ADDENDUM NO. 4

Reference: Residential Halls Buildings 2 and 3
Weber State University – Ogden, Utah
DFCM Project No. 10176810 and 11008810

Subject: **Addendum No. 4**

1 SOLAR WATER HEATING SCHEMATIC

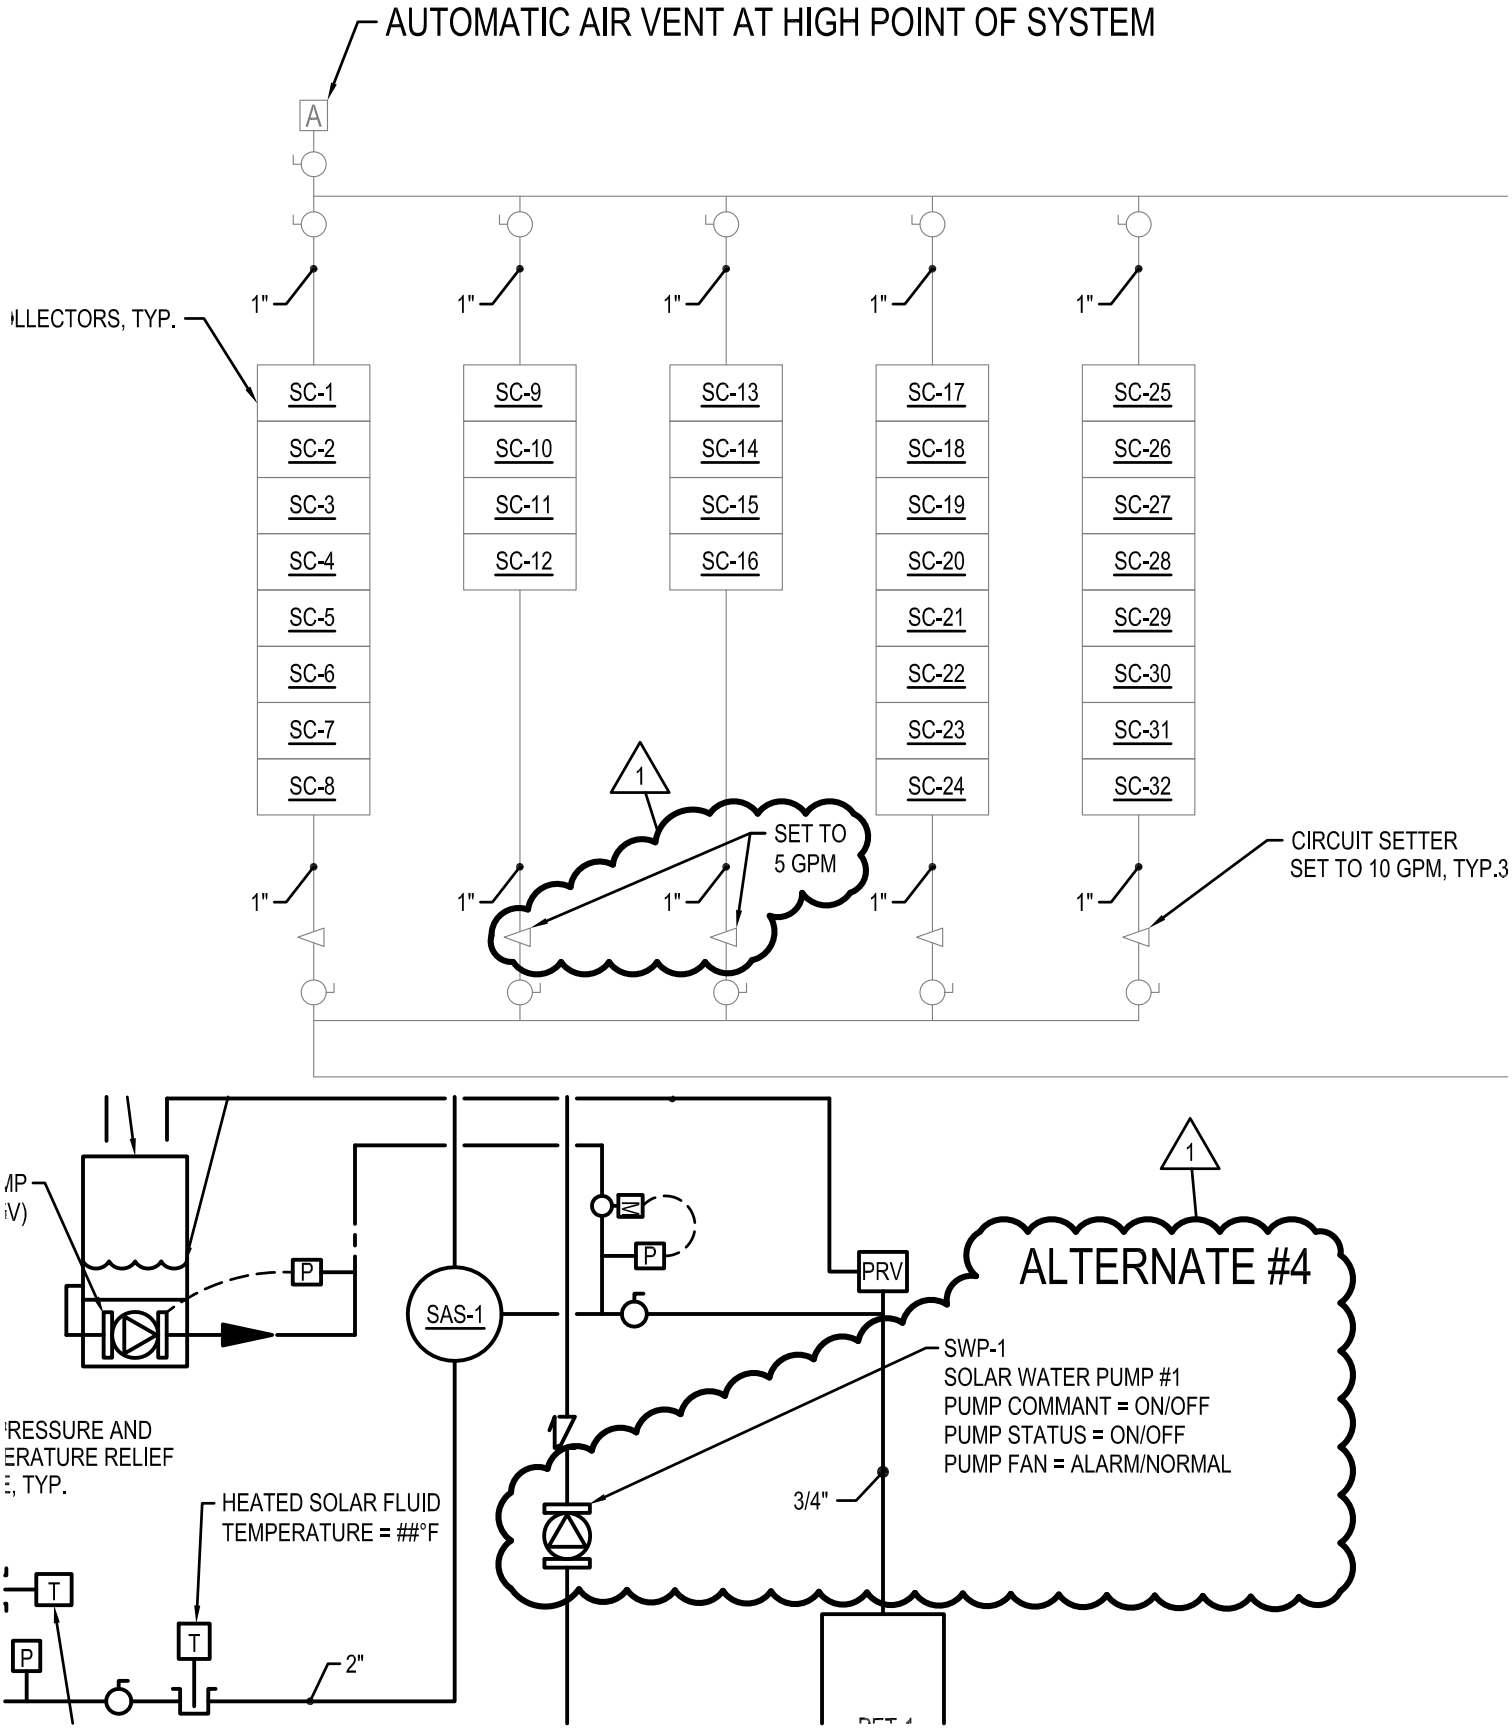
Item No.	Add, Delete or Clarify	Specification Section or Drawing No.	Reference / Description:
1	ADD	MH101	Thermostat & Co2 Sensor Detail 1
2	CLARIFY	MH101B	Clarify HP 29 to 30 & HP 3 to 23
3	CLARIFY	MH102B	Clarify Diffuser Callout
4	CLARIFY	MH103B	Clarifying callout HP 87 Diffuser Callout Room 33A Locate VFD 9, Show 8x8 EX air up to EF14
5	ADD	MH104B	Add FSD in duct
6	ADD	MHB302	Add main Mechanical Room
7	CLARIFY	MH401	Labeled HP 21 & 22
8	ADD	MH402	Add FSD & Motorized damper to MA Duct
9	CLARIFY	MH503	Detail 1 – Show Circuit balancing value & P/T plugs
10	CLARIFY	MH601	Clarified pump P8 & P9 Model # Clarified inner air temp. on mau
11	CLARIFY	MH602	Clarified EF-5 Voltage & Phase
12	ADD	MP401	Add isolation valves to hot water return
13	ADD	PL101B	Add connect water to refrig.
14	CLARIFY	PL301	Clarify Alt. #4
15	CLARIFY	PL402	Change Waste pipe from 3”x4” to match other sheets Add Garbage Disposal
16	CLARIFY	PL502	Detail #5 Clarify Alt #4

IRRIGATION PLAN BUILDING - 3

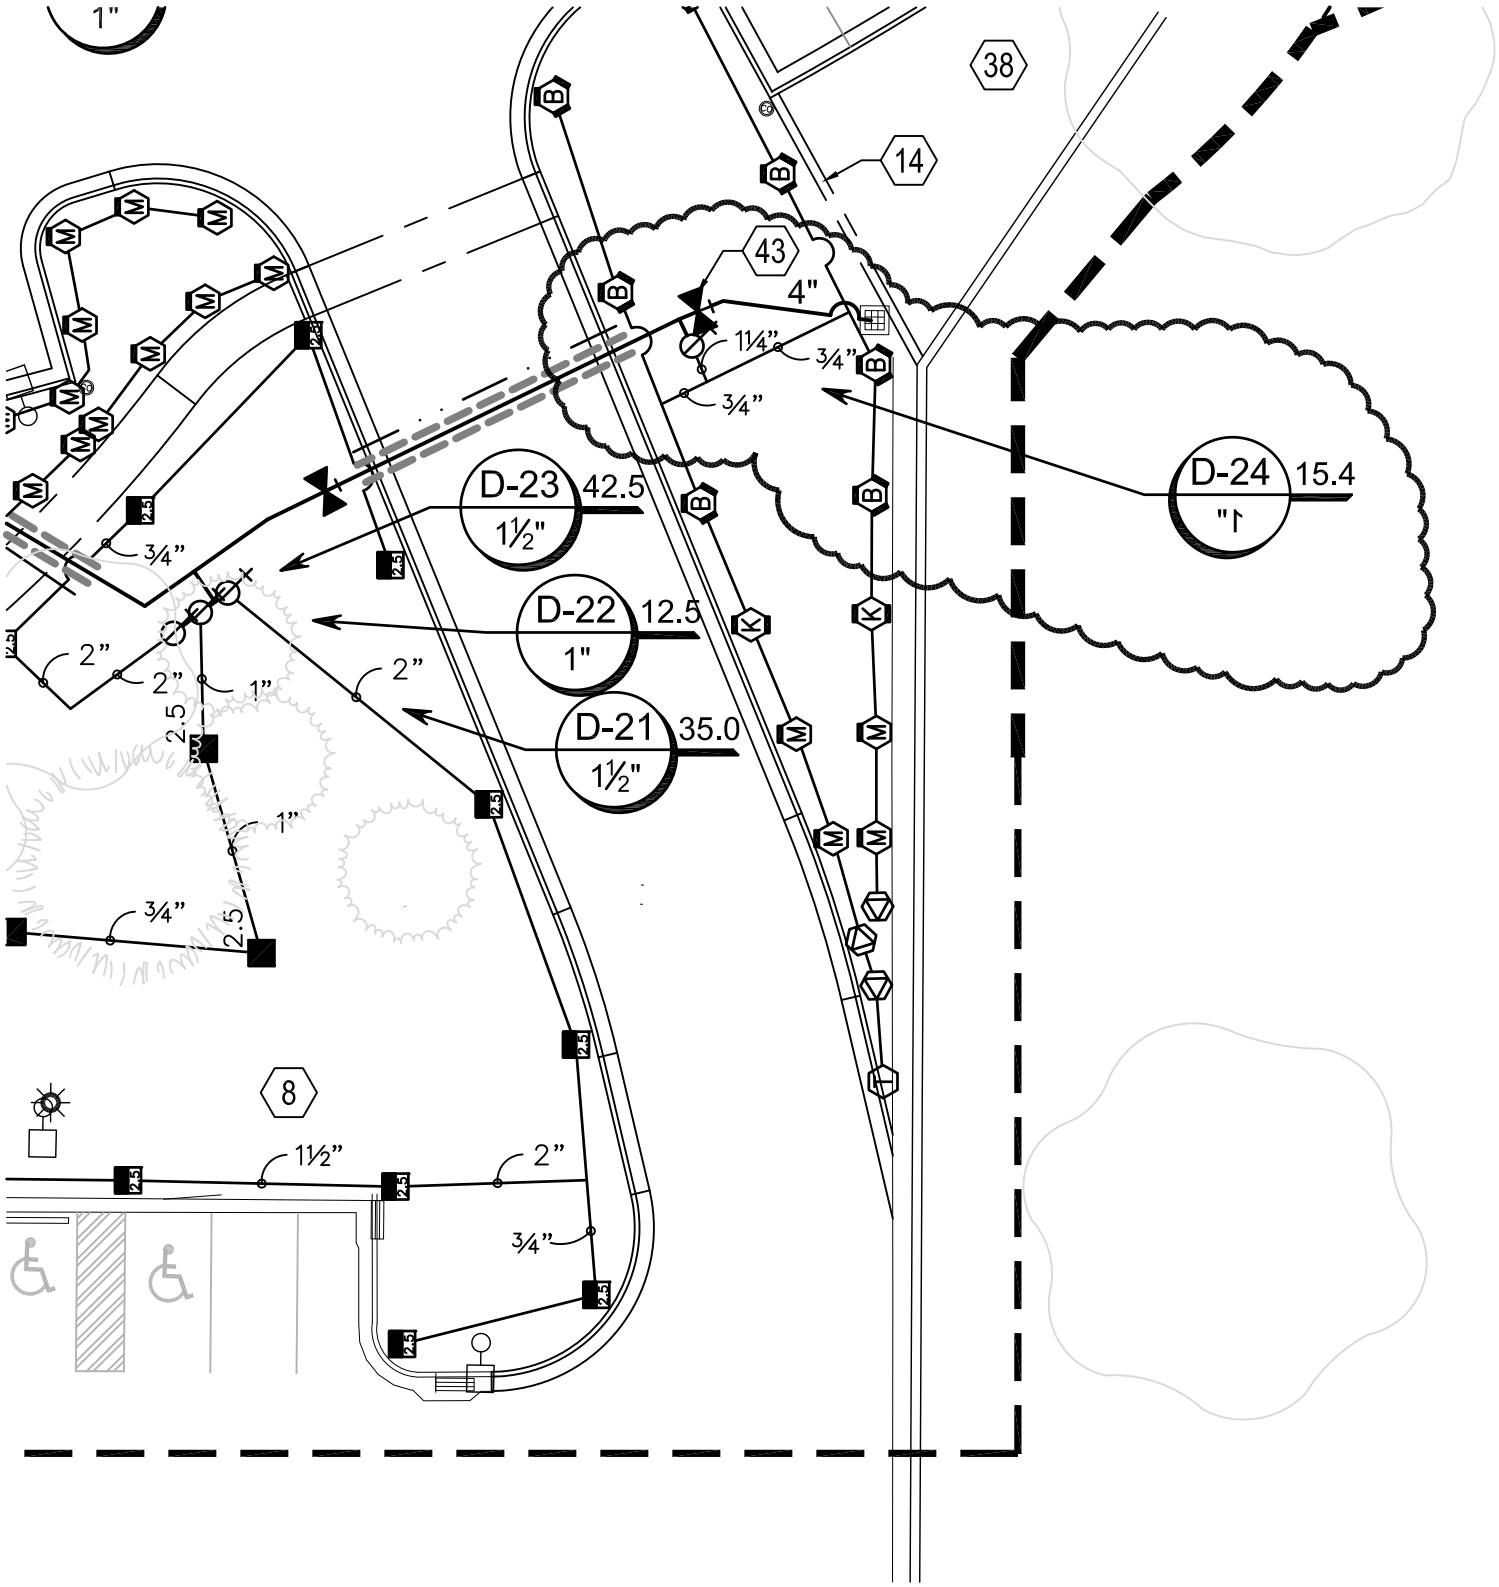
B. Revise the irrigation layout as per AD04-L06.

C1

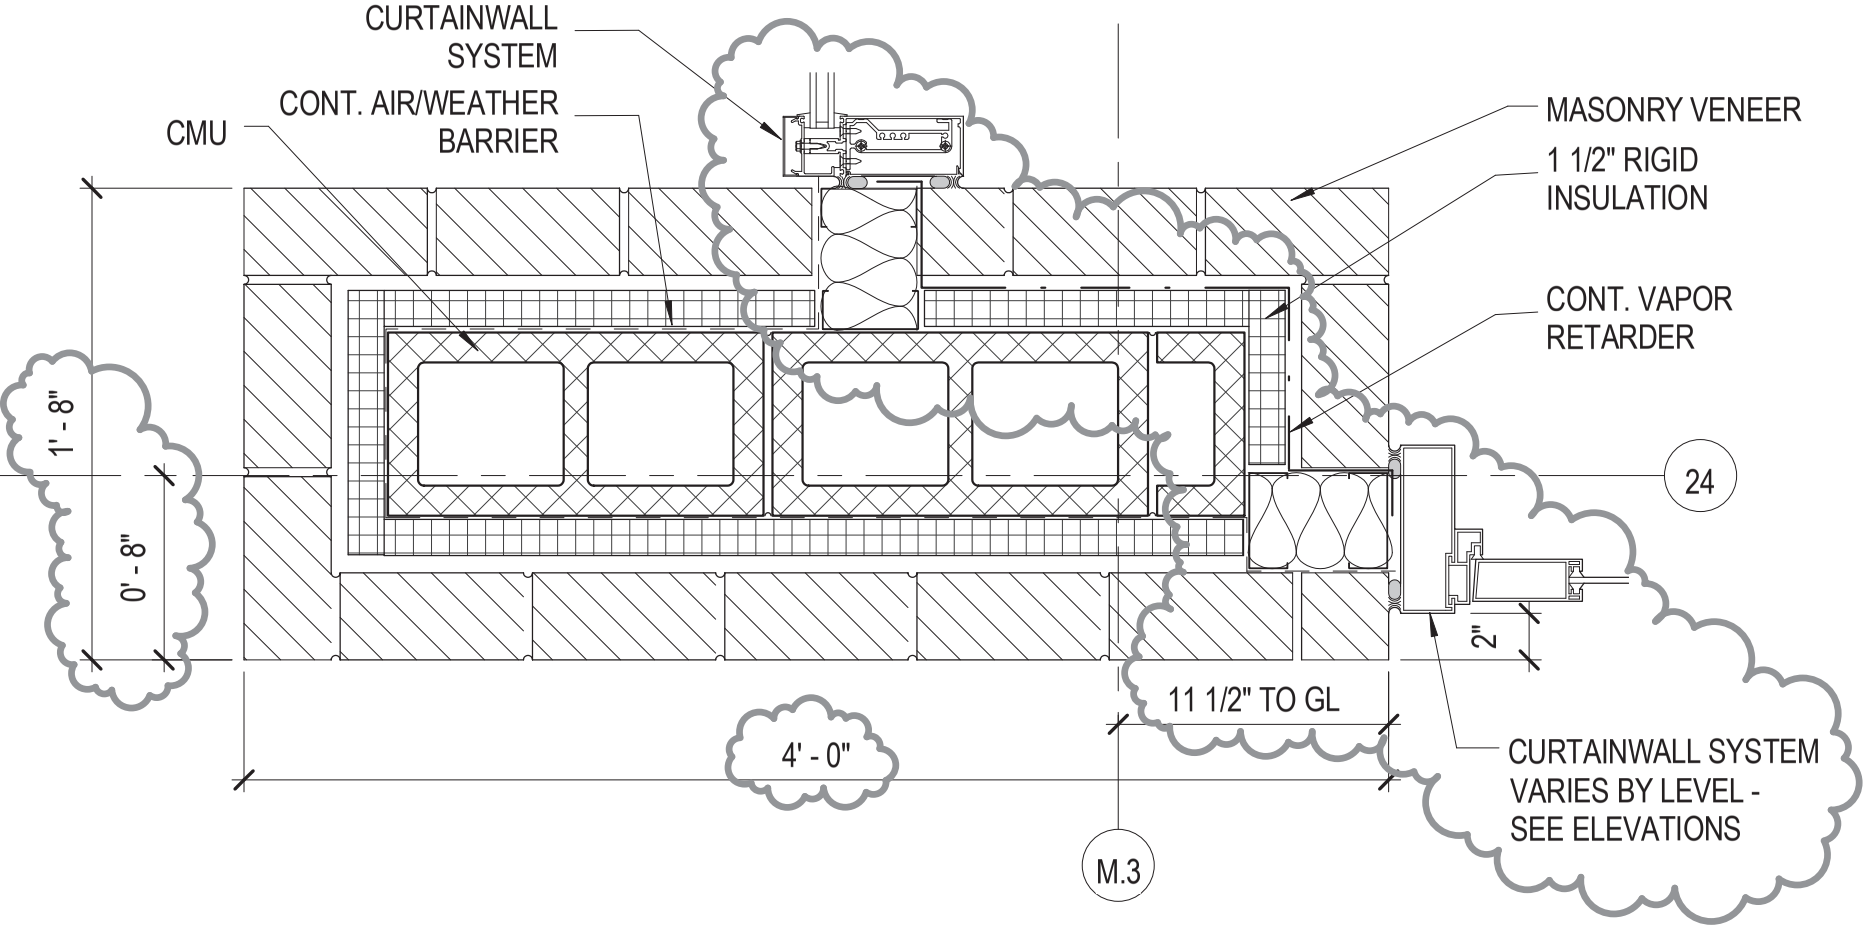
A. Revise Detail C1/AE501. See attached AD04_A12

SHEET NUMBER
AD04_S01
SHEET REFERENCE
SG601

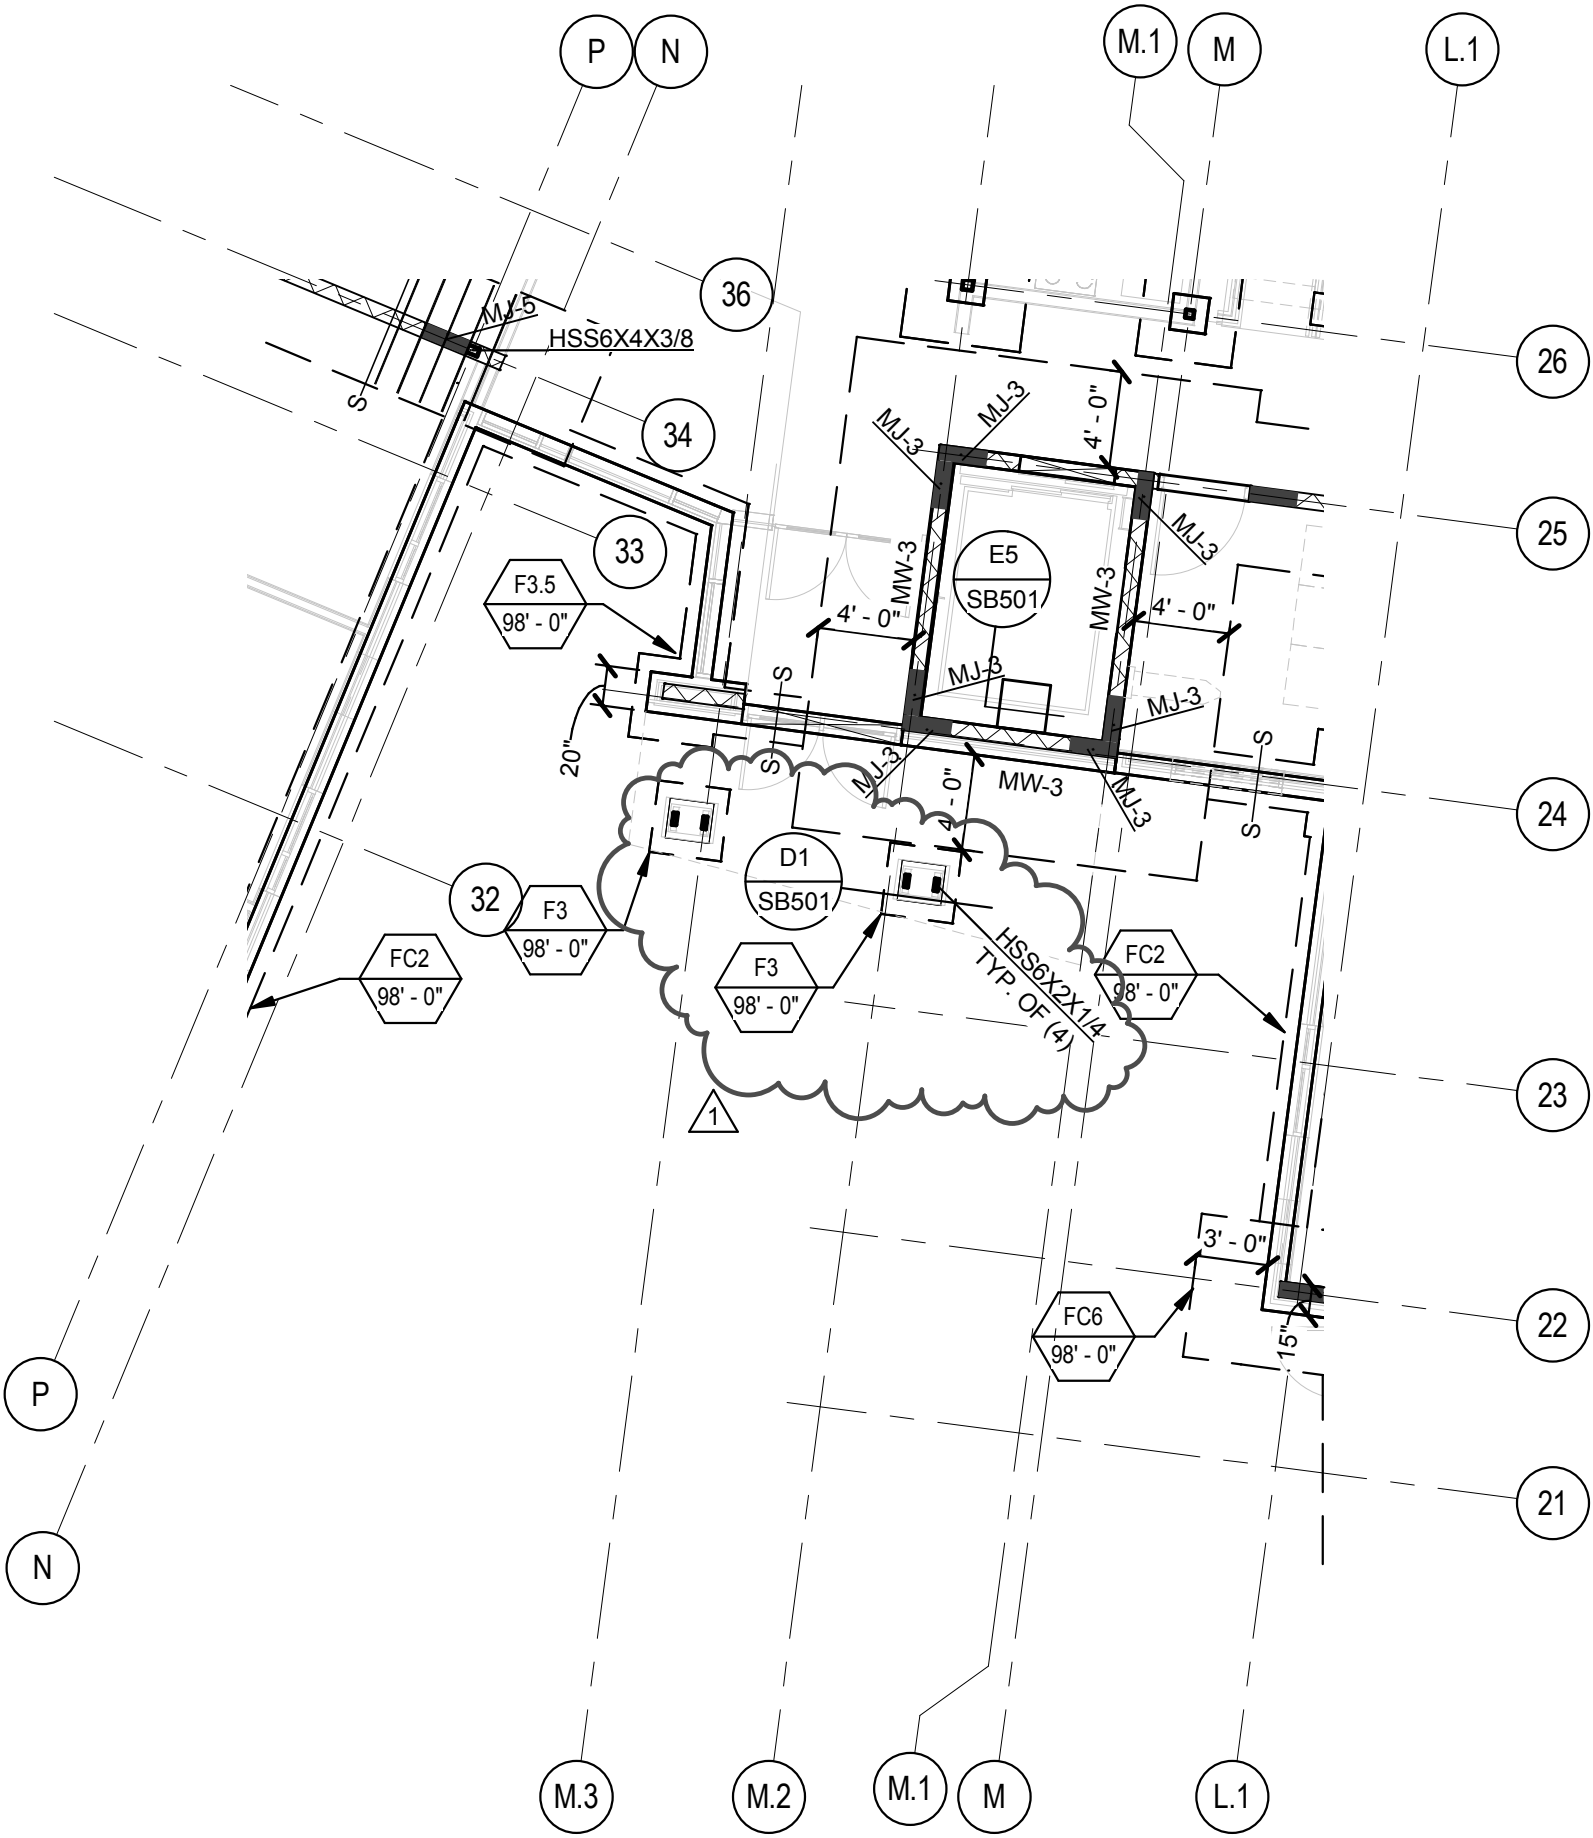
Sheet SG601
-The masonry shear wall schedule has been modified. Please see the attached sheet AD04_S01.
